PLAN COMMISSION PC #18-010
Arlington Downs Phase 2
3400 W. Euclid Ave.
PUD Amendment, Pre/Final Plat of Subdivision, LUV
Round 3 (revised)

Project: 3400 W. Euclid Ave.
Arlington Downs PUD Amendment

Case Number: PC 18-010

Arlington Downs
3400 W. Euclid
PC 18-010
May 24, 2018

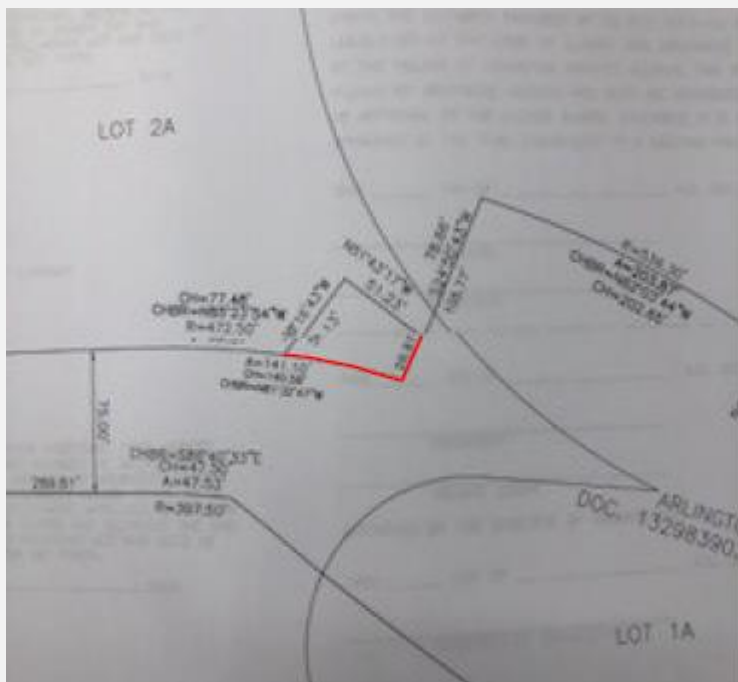
11. The response to Plat of Subdivision comments #2, and #6-#10 are acceptable.
12. The response to comment #1 is noted. Please refer to comment #79 above.
13. The response to comment #3 is noted. Please remove the small hangover of the previous portion of Lot 2 (indicated in red below), which is no longer relevant since Lot 2 no longer exists.
